To: Planning Committee *To Planning - Mar 18, 2008*
From: Brian J. Jackson, MCIP **Date:** February 25, 2008
Director of Development RZ 07-361266
Re: **Application by Orion Estates Ltd. for Rezoning at 7140 Railway Avenue from** *File: 12-8060-20-8343*
Single-Family Housing District, Subdivision Area E (R1/E) to Comprehensive
Development District (CD/54)

Staff Report

Re: 7140 Railway Ave, Richmond BC

Revised Tree Protection Report

SITE PLAN
SCALE 1:200
NORTH

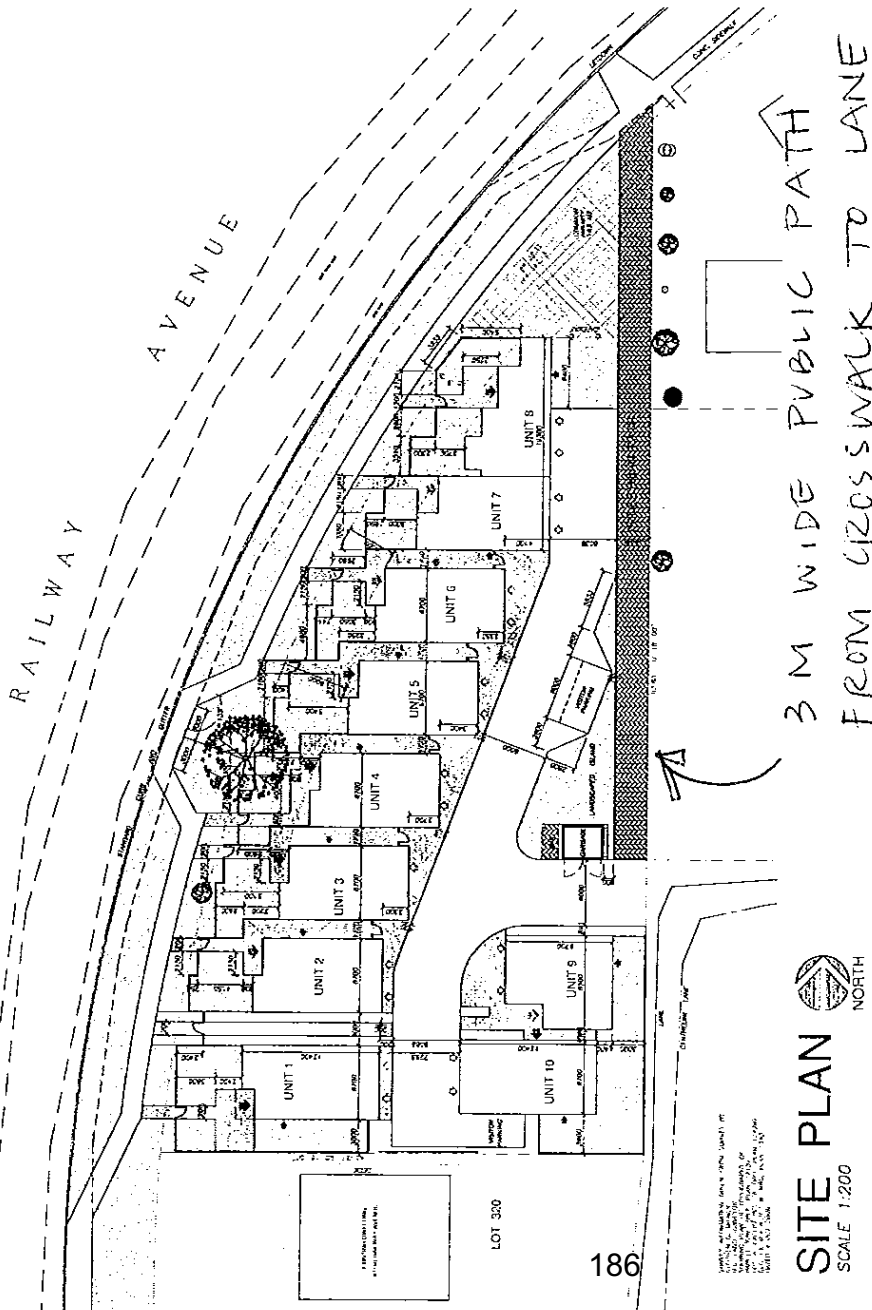
The applicant has developed a preliminary design for this site (**Attachment 4**). The following items will be further investigated at the Development Permit stage:

- Detailed review of building form and architectural character. Design development is needed throughout the project to provide articulation, harmonize proportions, rationalize garage design, and emphasize pedestrian orientation;

- The number and dimensions of off-street parking stalls, including accessible spaces, to be in accordance with the City Zoning and Development Bylaw, Division 400. Detailed dimensions of parking stalls to be provided on plans;

- Detailed mailbox and garbage/recycling structure design. The mailboxes to be at least 6 m away from the vehicle entry;
- Detailed landscaping design, including an internal on-site outdoor amenity area;

- Careful detailing of the building and front yard area adjacent to the Oak tree which is to be protected and retained in the boulevard. As noted previously, Parks Department staff is concerned about compounded impact of construction activity on the long-term health of the Oak tree. Successful protection will need coordination between the contractor, site arborist, engineering design consultant, City Engineering and Parks staff; and

TREE PROTECTION PLAN DRAWING
Showing All Trees Proposed For Retention
in Relation to the Proposed Site Layout

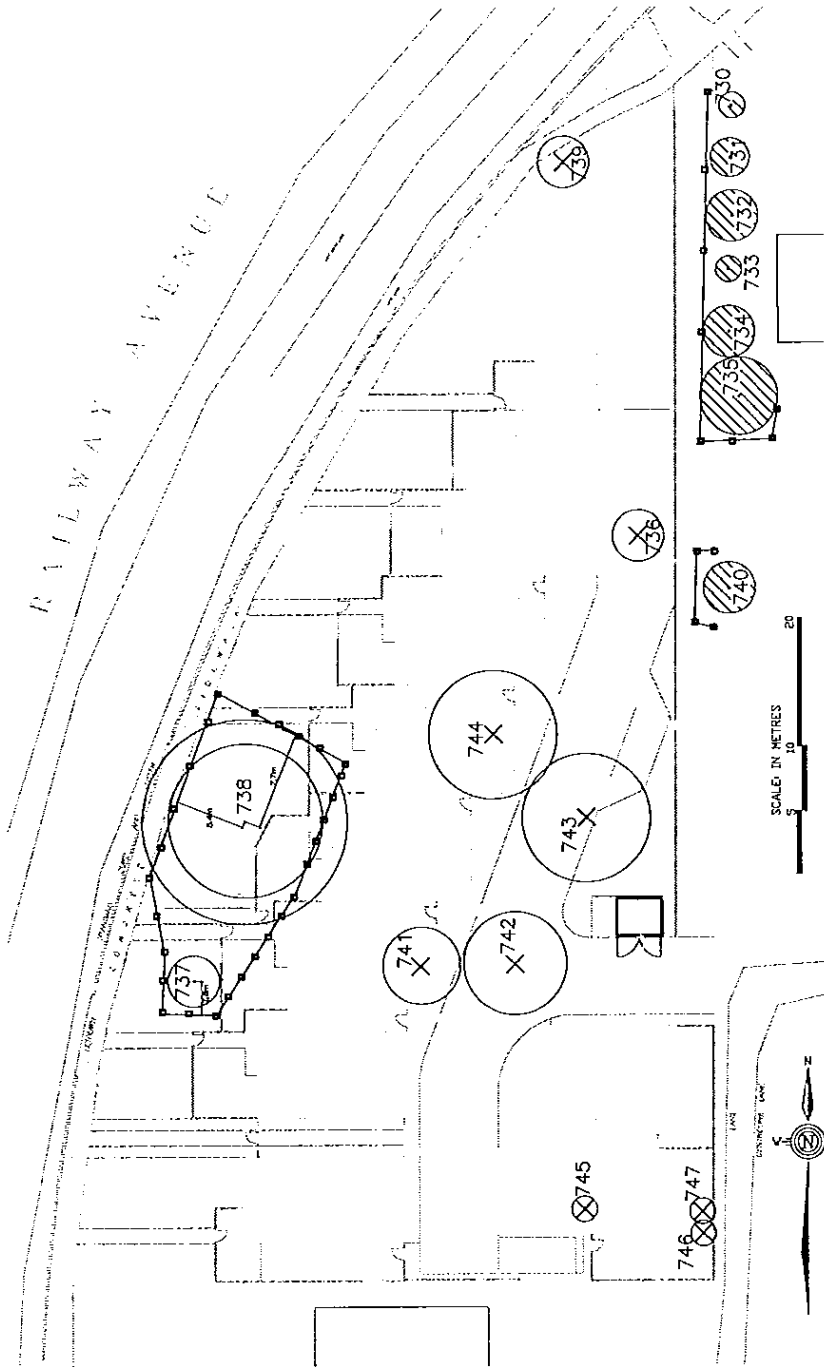
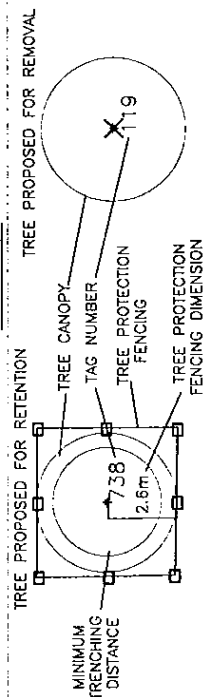
A **Tree Protection Plan** drawing, which plots all trees proposed for retention, removal and Tree Protection Fencing in relation to the proposed development layout is attached as **Appendix—3**.

All retained trees on the City Property and neighbouring properties will be surrounded by Tree Protection Fencing as laid out in the **Tree Protection Plan** drawing Appendix 3. All fencing must be constructed to a robust standard and clearly signed: "TREE PROTECTION AREA – KEEP OUT" See Appendix 2 for construction details.
